October 15, 2021

Re: Conservation Organizations Comments on North Carolina's Proposed Regional Haze State Implementation Plan (SIP) for North Carolina Class I Areas for the Second Planning Period (2019 - 2028)

Figure 13. Cliffside Unit 5 Historical SO₂ and NO_x Monthly Emissions

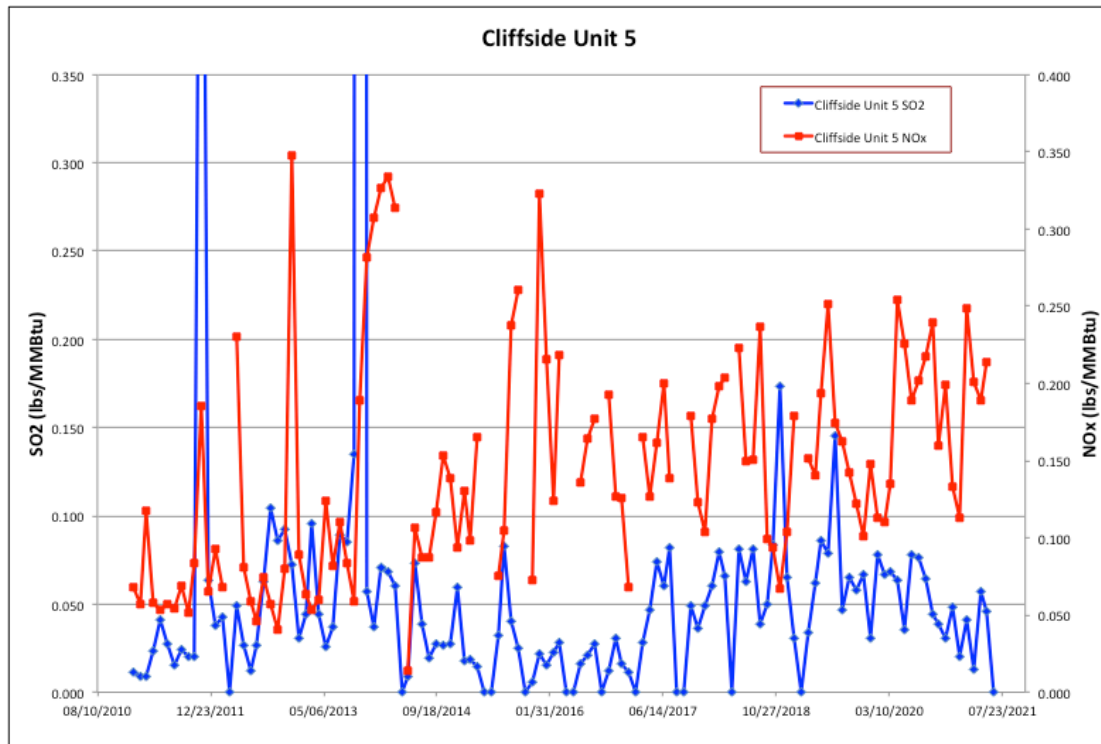
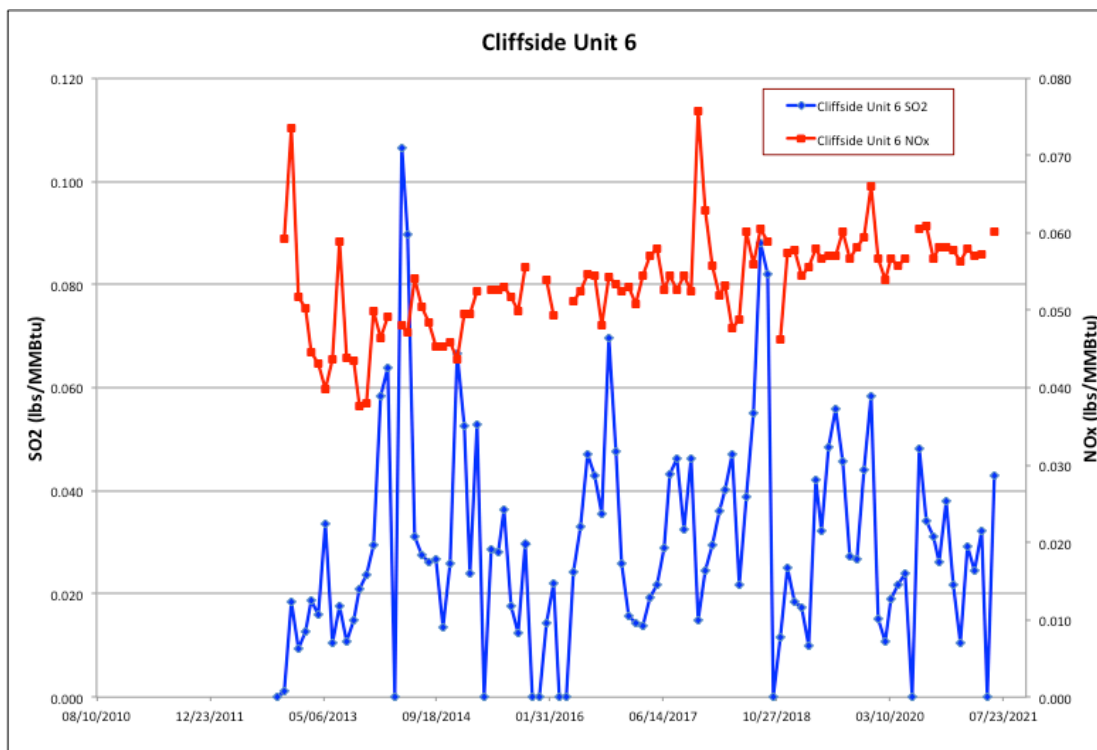
Duke Energy states that in 2018, natural gas was added to the station, allowing up to 40% natural gas co-firing on unit 5 and up to 100% on unit 6. EIA-923 data indicates that both units began using natural gas at the beginning of 2019. Unit 6 appears well controlled for NO_x and SO₂, but has demonstrated the capability to control NO_x slightly below its present levels. Considering that the facility is now burning natural gas in addition to coal, there is likely considerable room for improvement. Unit 5 has demonstrated the ability to consistently control SO₂ to below 0.04 lbs/MMBtu. However, recently Unit 5's SO₂ levels have climbed somewhat. Unit 5 has demonstrated the ability to consistently control NO_x to approximately 0.05 lbs/MMBtu on a monthly basis. However, over the past ten years Unit 5's NO_x level has steadily climbed. Likely, the reason for the lax performance of these control systems is that Cliffside's permit doesn't require better performance. Thus, very cost-effective controls are available for these units for likely just the increase in reagent and potentially better catalyst management and additional electricity for running all absorber pumps. NC DEQ should have required a four-factor analysis for this unit and investigated this issue.

Figure 15. Cardinal Unit 1 Monthly Average SO₂ and NO_x emissions.

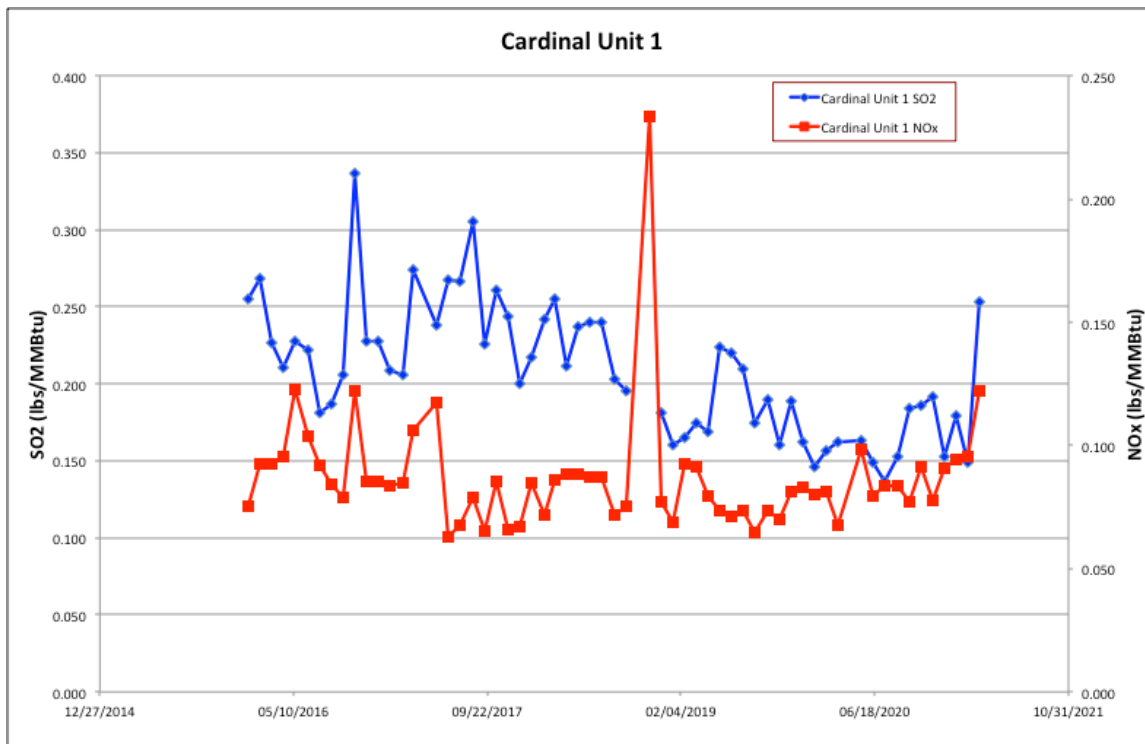
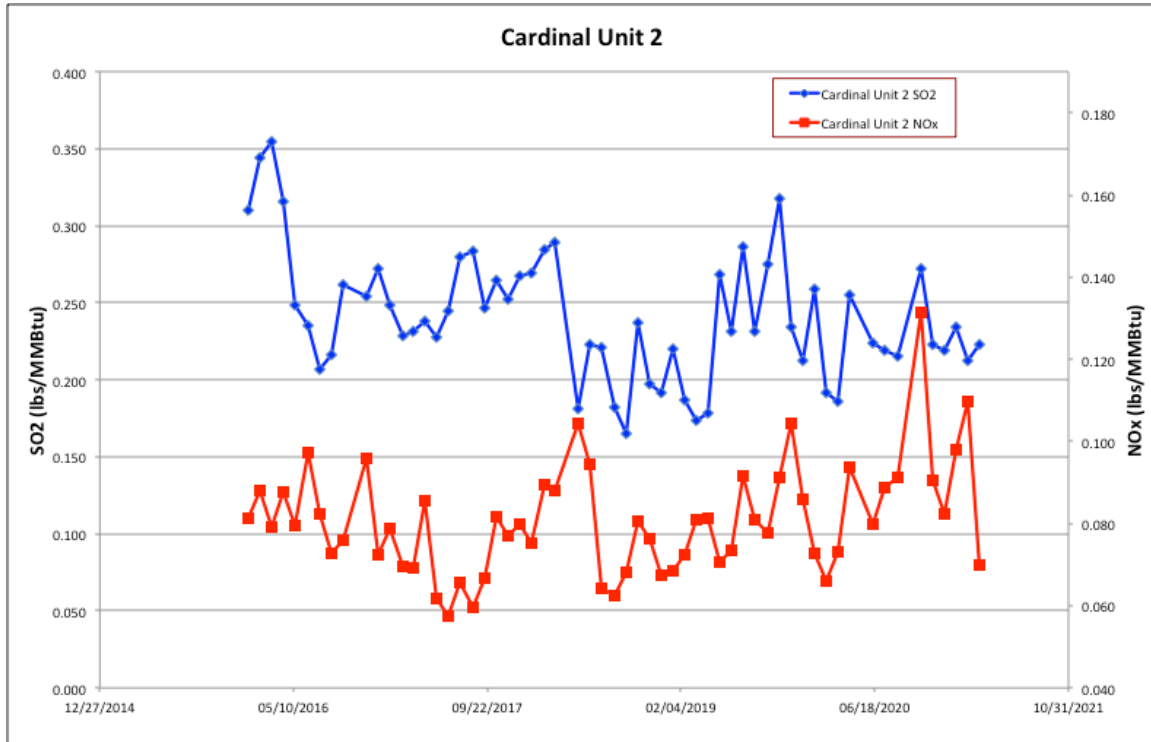
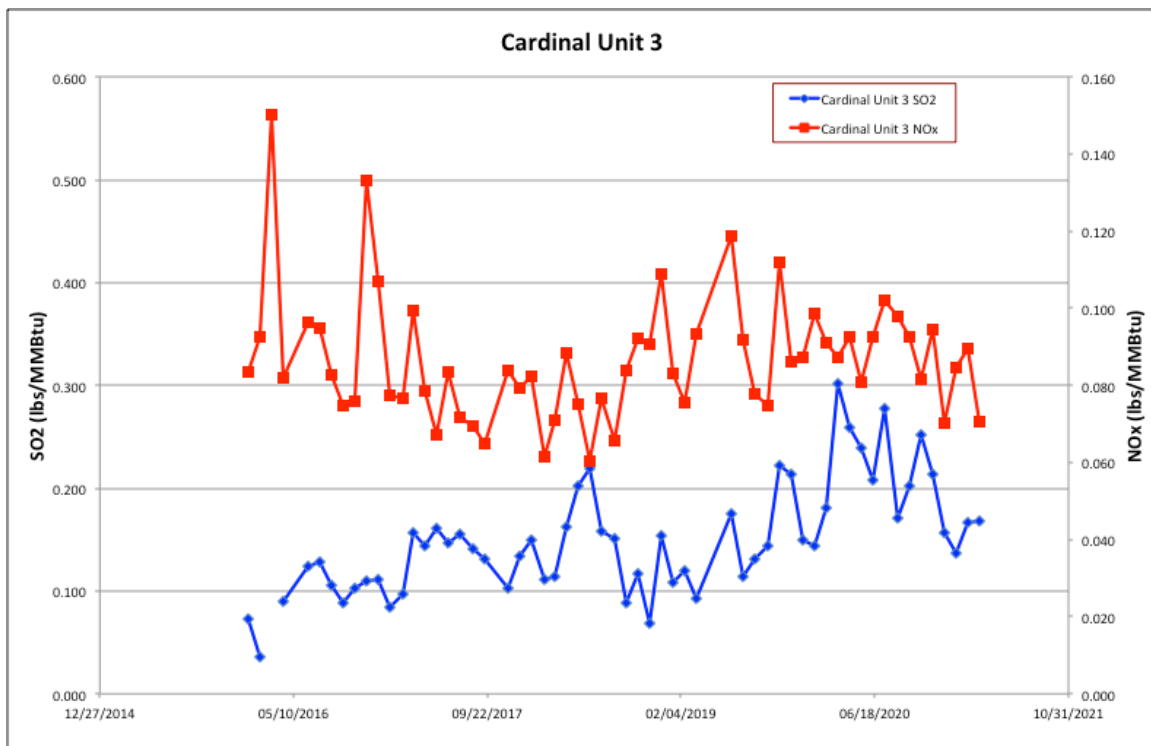
It can be seen from the above graphs, that the monthly SO₂ emissions for the Cardinal units are fairly variable, which suggests that Cardinal's scrubbers can be further optimized.

Similar observations can be made regarding the performance of the Cardinal SCR systems. It appears from the above graphs that the performance of Cardinal's SCR systems is suboptimal, with recent monthly NO_x averages typically ranging from 0.06 – 0.12 lbs/MMBtu.

Figure 18. Cardinal Unit 1 Historical 30 Boiler Operating Day (BOD) NOx Performance

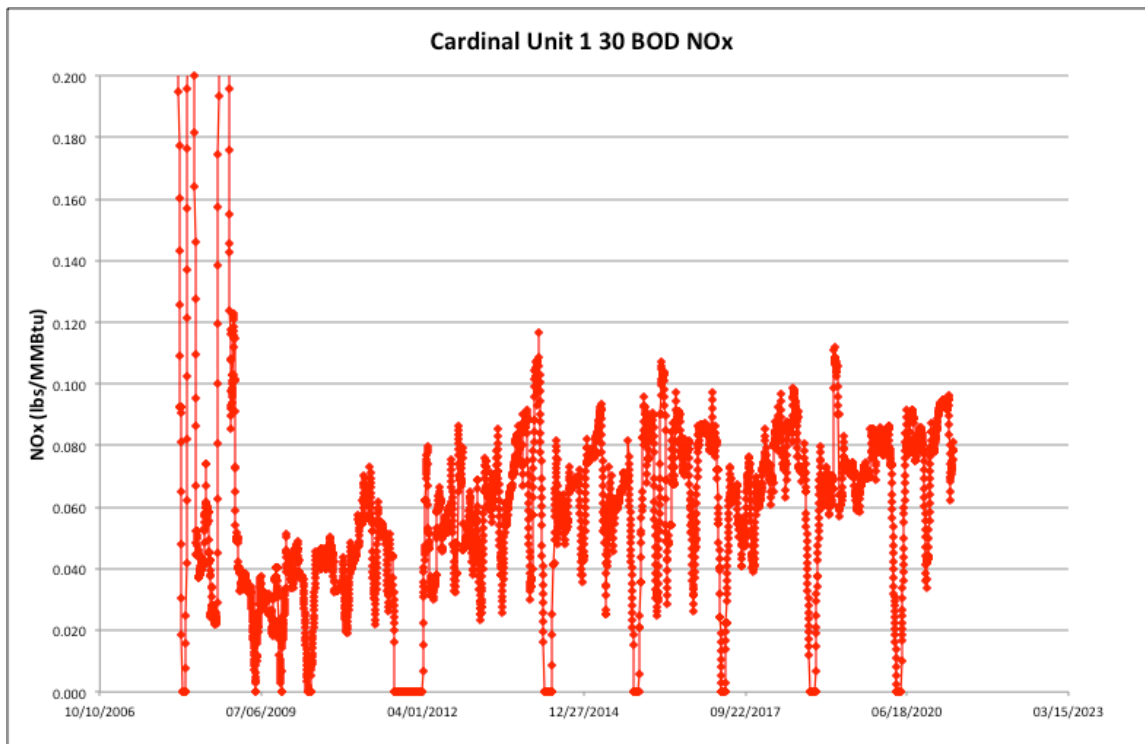
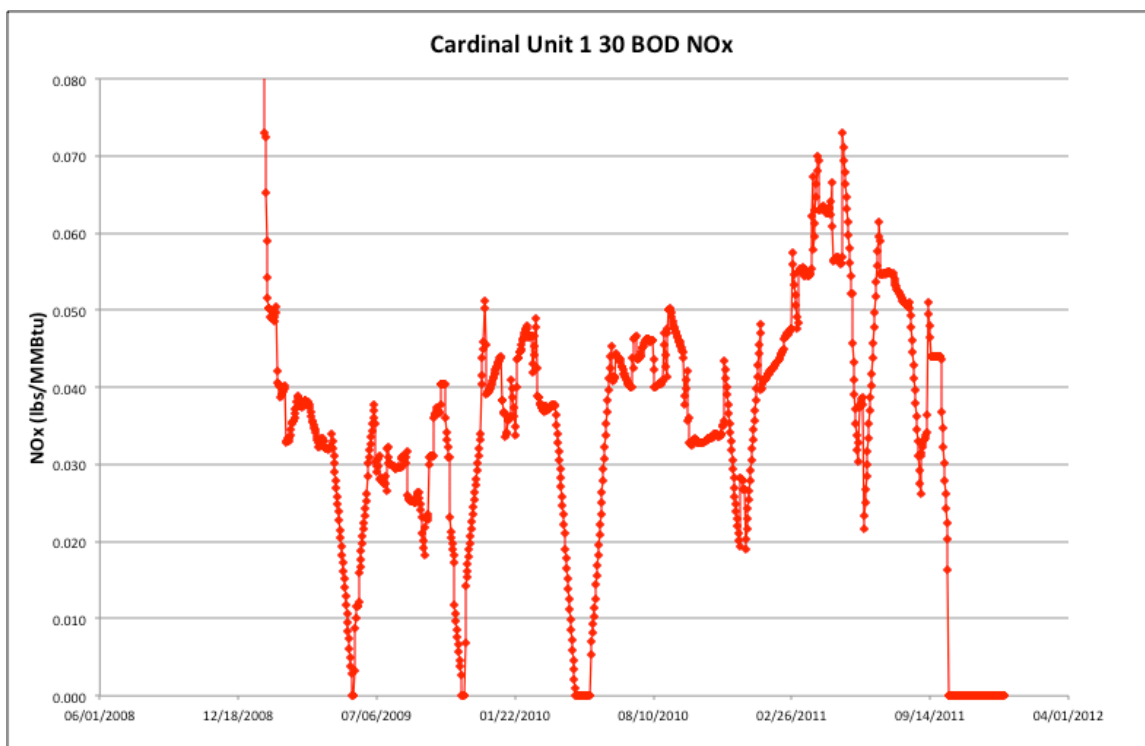
The above figures illustrate the Cardinal Unit 1 SCR system performance during two different time intervals. The NO_x emissions are plotted based on a 30 BOD average.²⁹ As can be seen from Figure 6, the Cardinal Unit 1's SCR performance has gradually worsened over time. Figure 7 illustrates the SCR performance for the first two years after it was first installed. As can be seen, the SCR system is capable of sustained performance under 0.04 lbs/MMBtu. An examination of Cardinal Units 2 and 3 SCR systems reveals similar capabilities. In fact, the performance of the Cardinal Units' SCR systems was formerly so good that EPA included it in its survey of the best coal-fired EGU SCR systems to support its New Mexico FIP, which concluded that SCR systems for the San Juan Generating Station were not only cost-effective, but should be required to meet a NO_x rate of 0.50 on a 30 BOD average.³⁰ Cardinal's Title V permit does not appear to specify any NO_x emission limits for the units that would approach 90% control.³¹ Thus, it appears that the only thing preventing the Cardinal units from achieving this level of SCR performance again is the lack of an enforceable NO_x limit requiring it. Consequently, although Ohio performed a four-factor analysis on the Cardinal units, it wrongly concluded no controls were necessary.³² NC DEQ should have objected to this conclusion, as it appears likely that additional NO_x reductions could be achieved very cost-effectively. More SO₂ reduction could be a matter of Cardinal simply running its scrubber systems at full capacity continuously or utilizing common scrubber upgrades discussed in another comment.

Figure 20. Kyger Creek Unit 1 Recent Monthly Average SO₂ and NO_x emissions

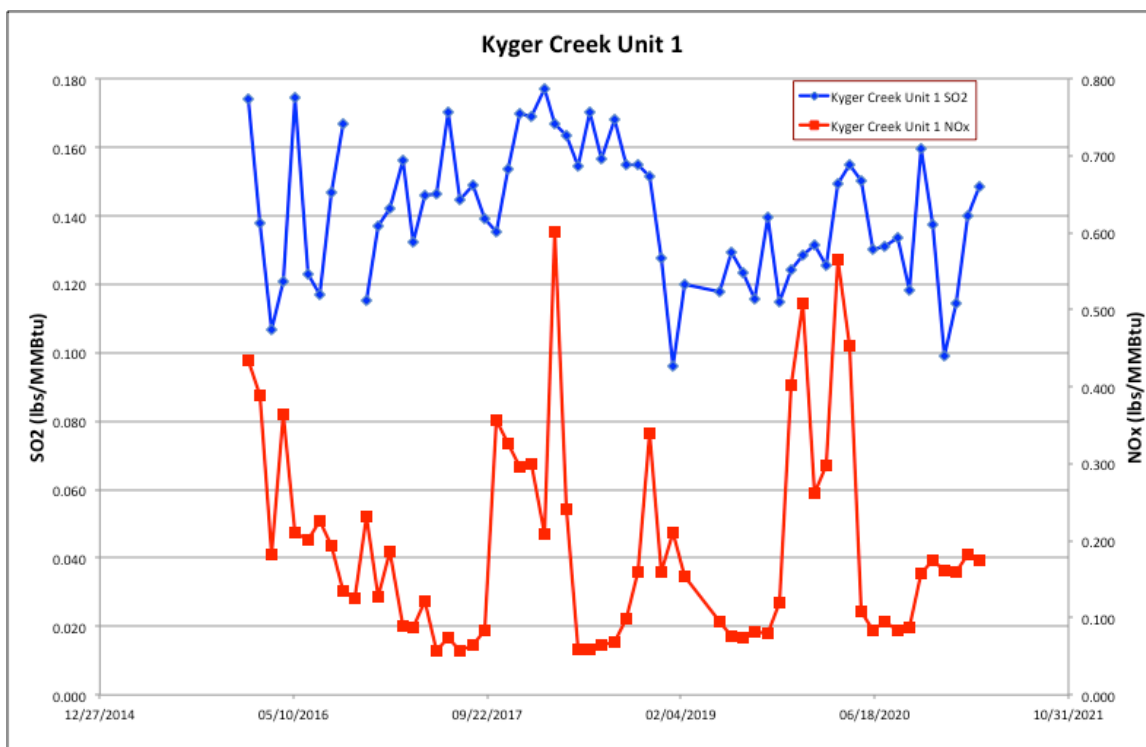
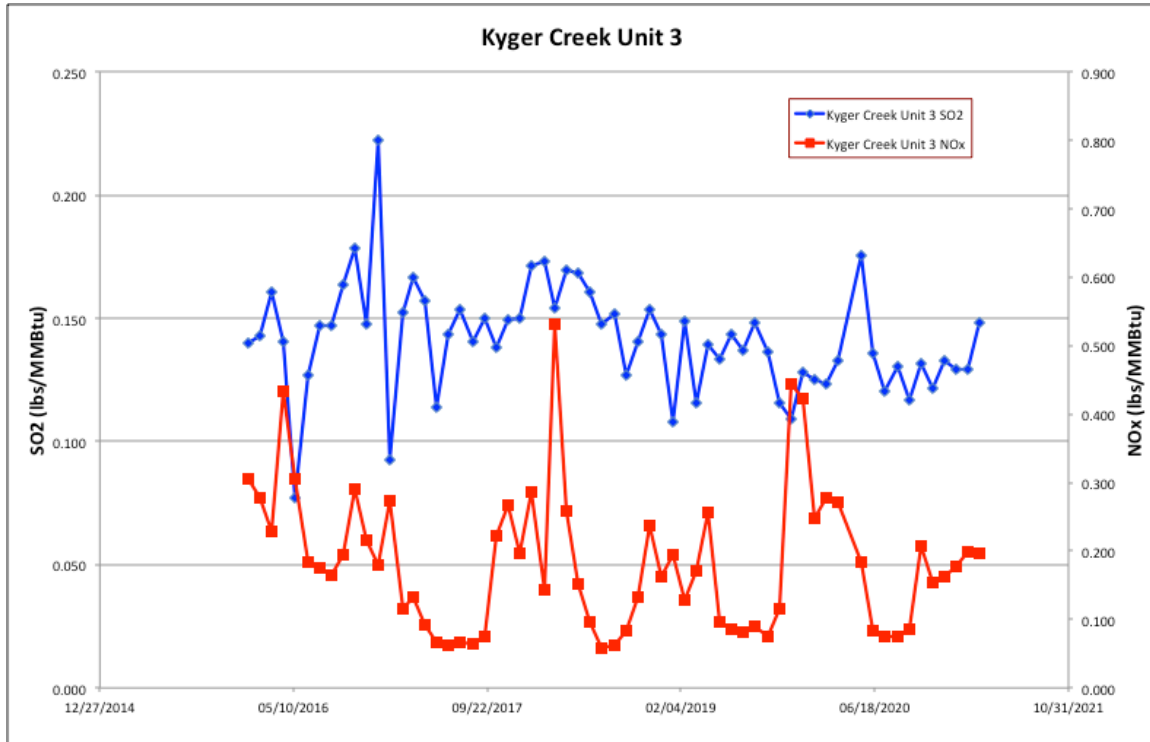
As can be seen from the above graphs, the monthly SO₂ emissions for the Kyger Creek units are fairly variable, which suggests that Cardinal's scrubbers can be further optimized.

Figure 22. Kyger Creek Unit 1 Historical Monthly NOx Emissions

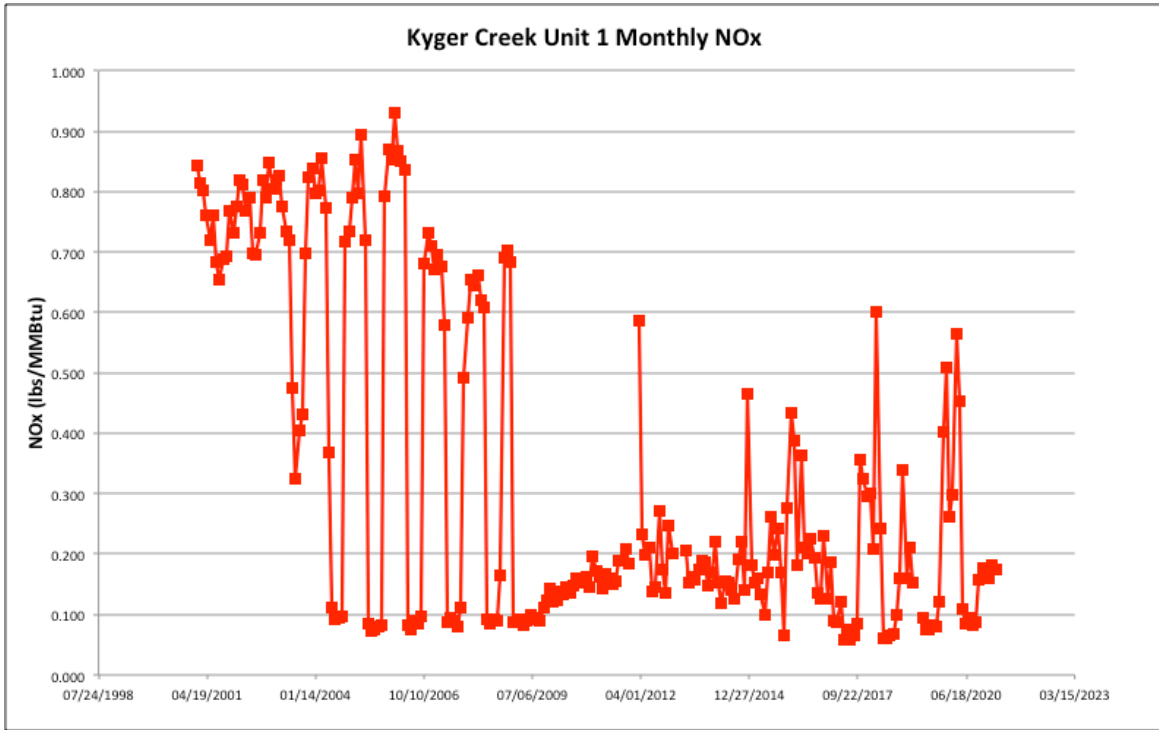
Also, the performance of the Kyger Creek SCR systems alternates between 3-4 month periods of good NO_x removal (approximately 0.06 – 0.08 lbs/MMBtu) with the rest of the time consisting of poor NO_x removal. It seems evident the facility only utilizes its SCR systems at their full capabilities during ozone season. This indicates that the true current performance potential of the Kyger Creek SCR systems is likely at least 0.06 lbs/MMBtu. The pre-SCR NO_x level of Unit 1 is shown below:

Averaging the monthly NOx rates prior to the SCR installation in May, 2003 yields the following:

Figure 23. Seward Unit 1 Historical SO₂ and NO_x Monthly Emissions

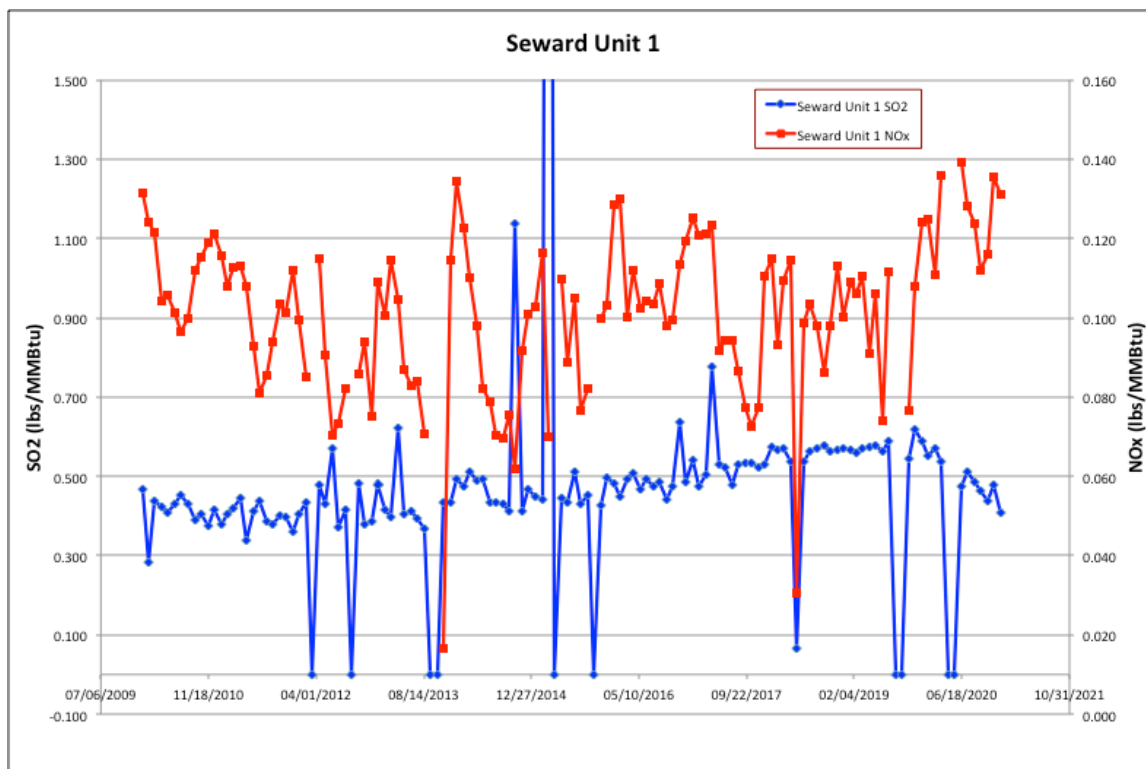
From the above graphs, it can be seen that the NO_x and SO₂ controls for these units are not operated at a consistent level and are capable of better performance than recently exhibited. For instance, at multiple times, the SNCR systems have controlled NO_x to below 0.8 lbs/MMBtu, but typically operate much above that level. Also, in 2010 – 2012, the NID systems have controlled SO₂ to below 0.4 lbs/MMBtu but have gradually risen over time to approximately 0.6 lbs/MMBtu. Thus, without any capital upgrade cost (and likely minimal operating and maintenance costs), the Seward units are quite capable of much better NO_x and SO₂ performance. It appears the only reason they do not is that they are not required by a permit condition to do so. Additional reductions may also be possible with very moderate and likely
